D
C
B
A
UNCLASSIFIED
DP2 SUBMISSION - P1338 BUILDING - PRE-FINAL SUBMISSION

DEPARTMENT OF THE NAVY
 NAVAL FACILITIES ENGINEERING COMMAND
 NAVAL FACILITIES ENGINEERING COMMAND ~ MID-ATLANTIC
 ROICC FLORENCE CAMP LEJEUNE
 JACKSONVILLE, NC
 JACKSONVILLE, NC
 P1338 II MEF SIMULATION/TRAINING CENTER
 REPLACEMENT
 PLUMBING - UNDERGROUND PLAN - AREA A

PLUMBING - ENLARGED PLAN - AREA A SANITARY & VENT

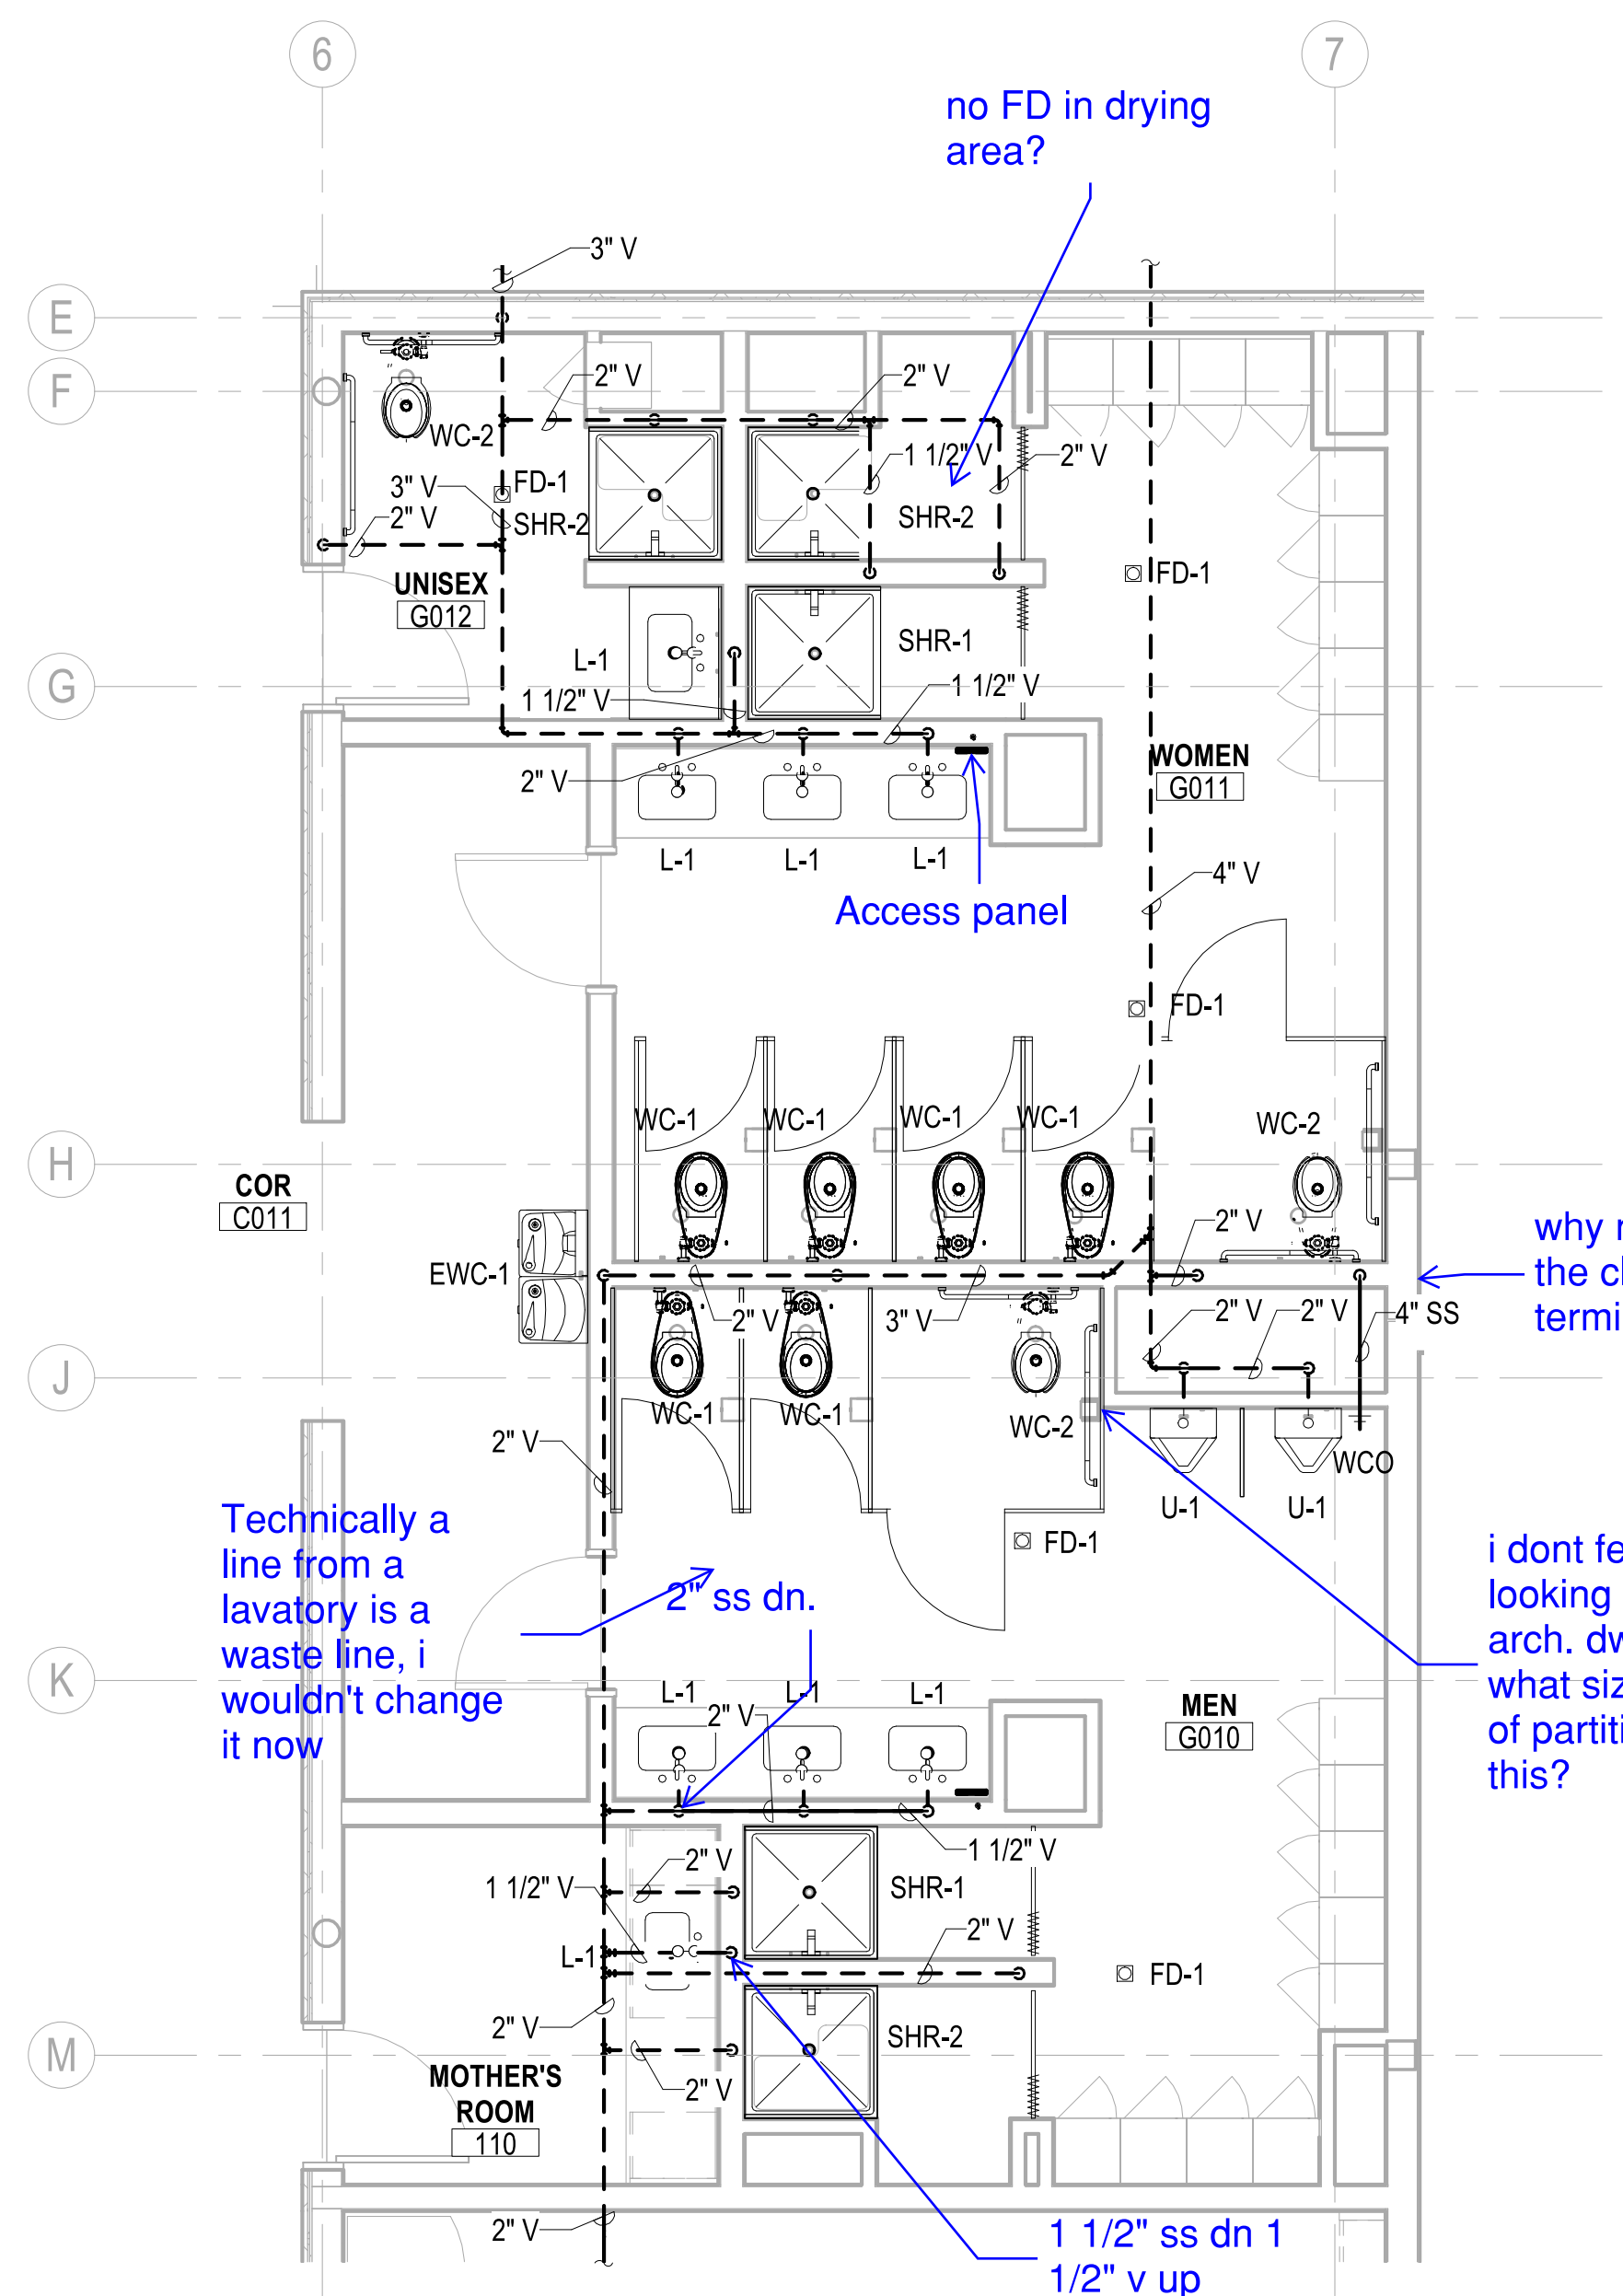
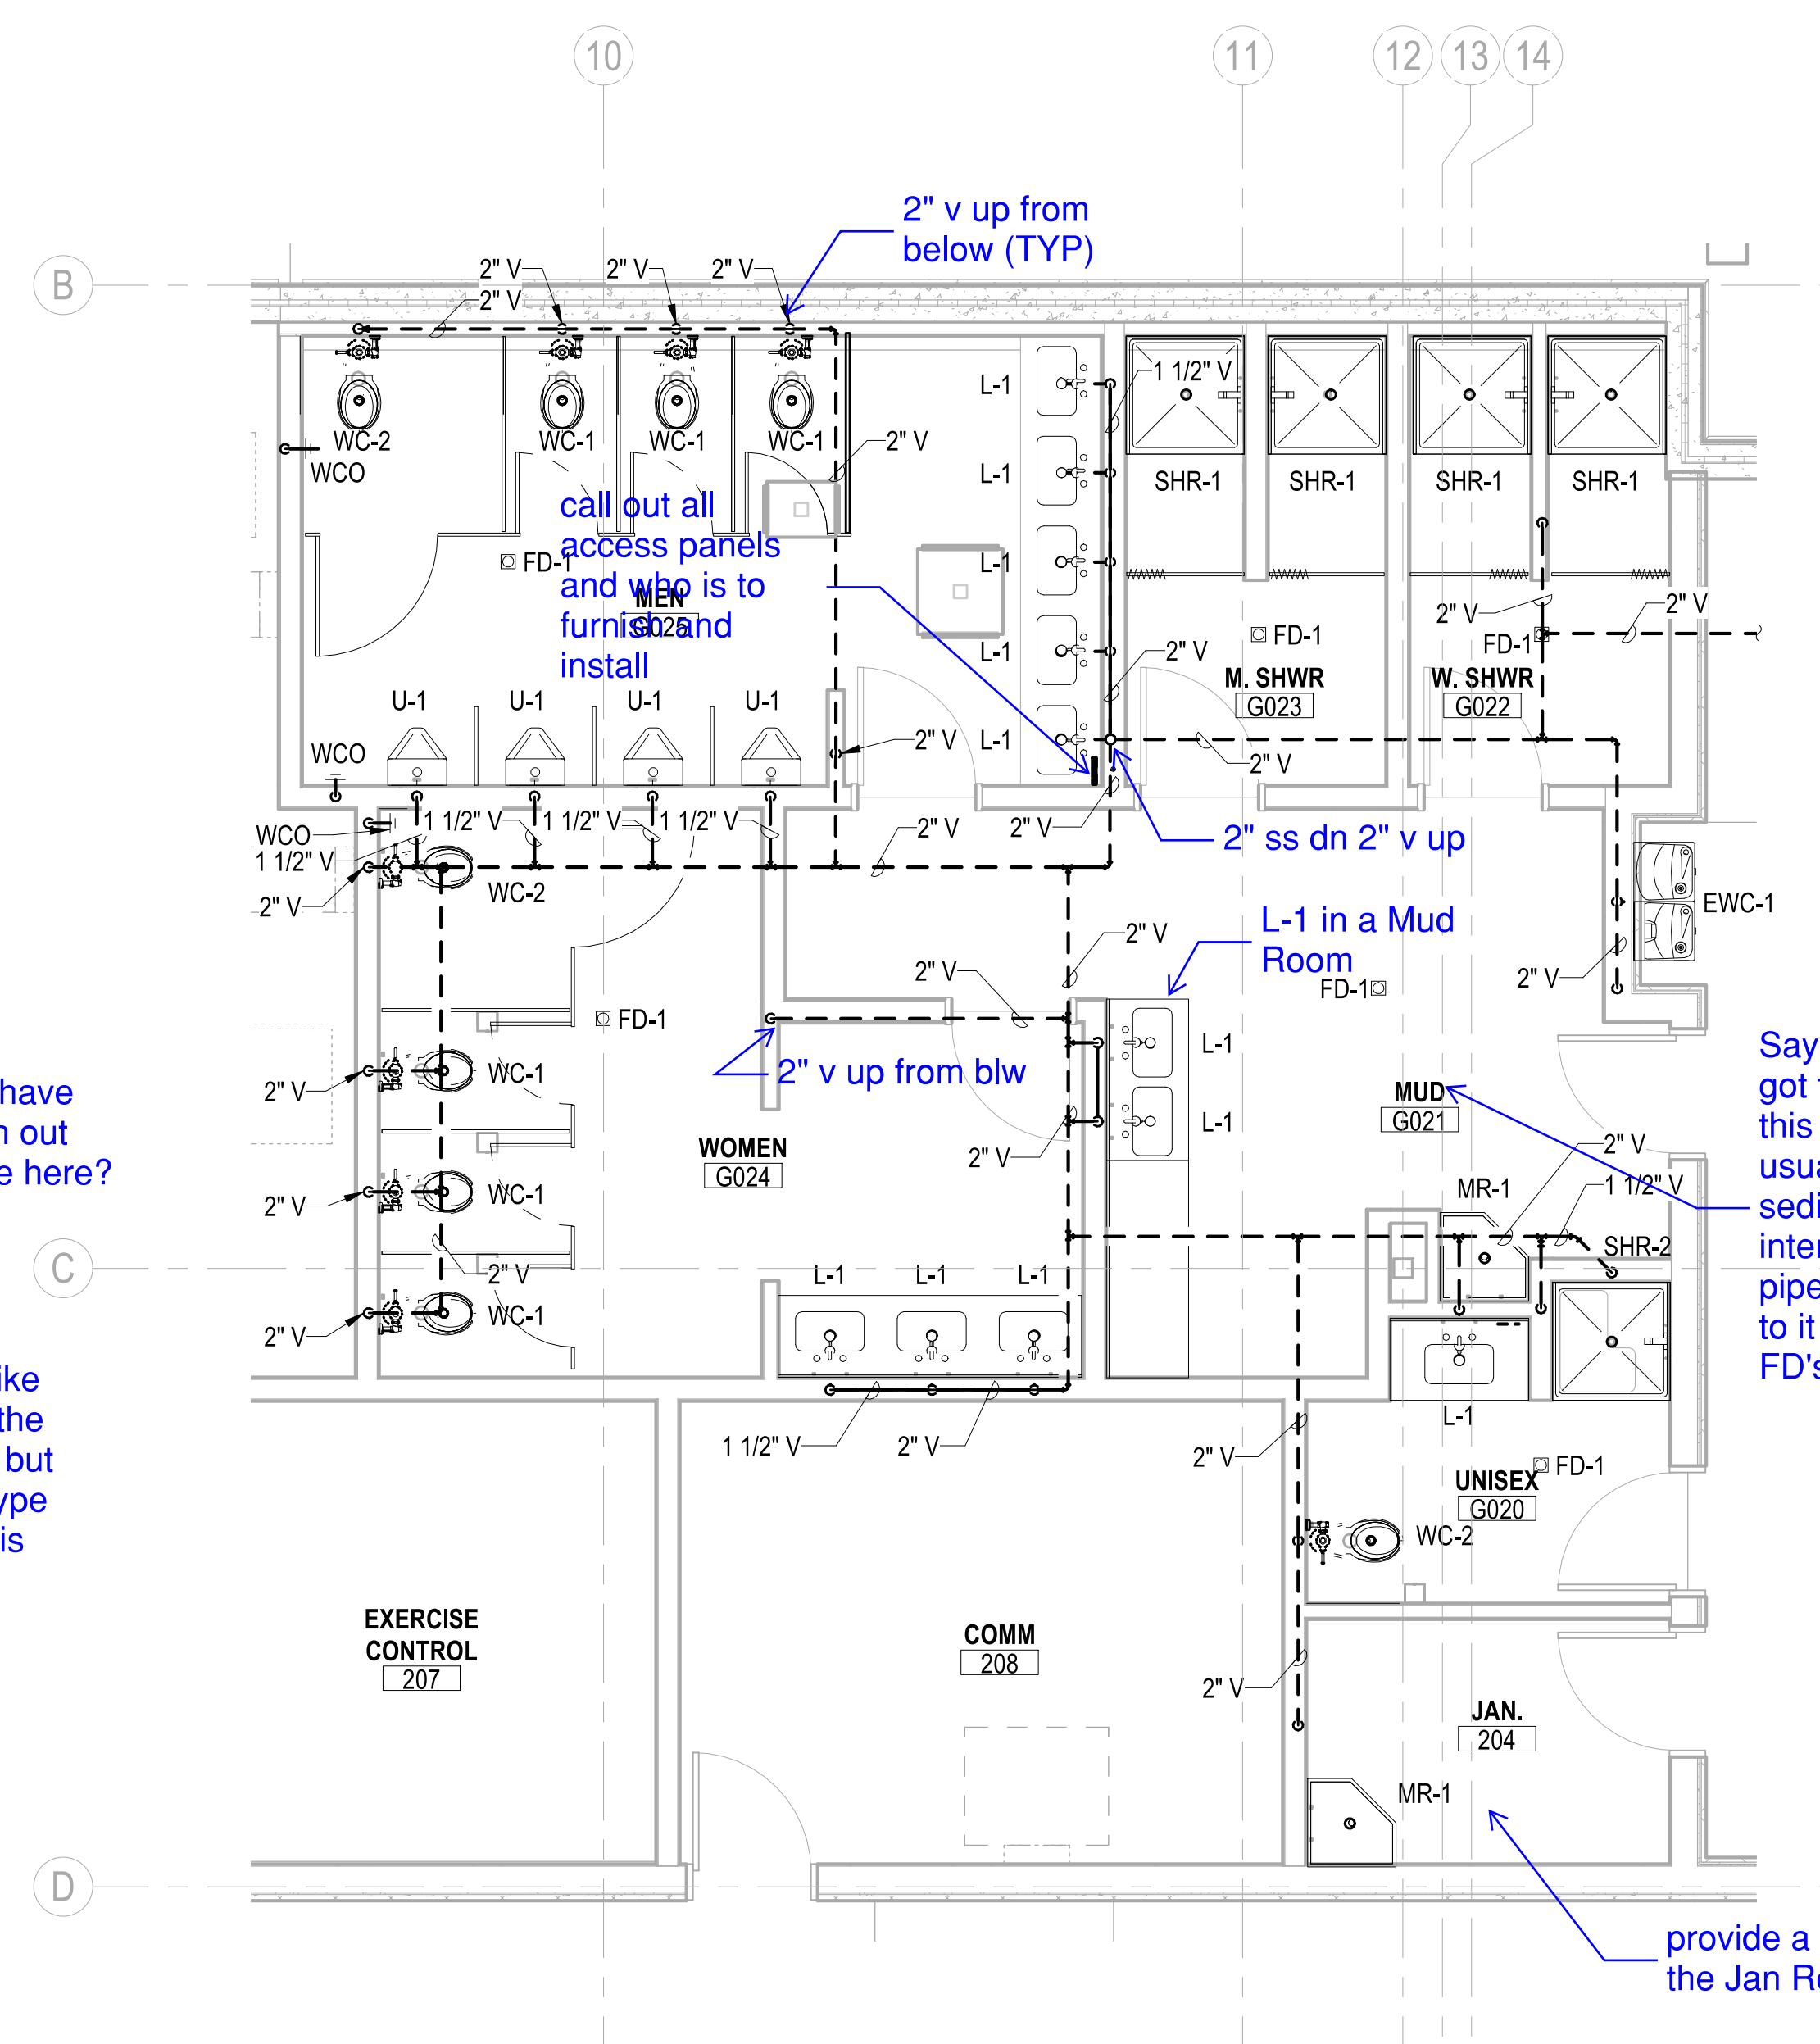
no FD in drying area?

Access panel

Technically a line from a lavatory is a waste line, i wouldn't change it now

2" ss dn.

1 1/2" ss dn 1 1/2" v up

why not have the clean out terminate here?

i dont feel like looking on the arch. dwgs but what size/type of partition is this?

2" v up from below (TYP)

call out all access panels and who is to furnish and install

2" ss dn 2" v up

L-1 in a Mud Room

2" v up from blw

Say what? we got to talk about this room. we usually install a sediment interceptor and pipe all fixtures to it including FD's

nothing in the rfp?

provide a FD in the Jan Room
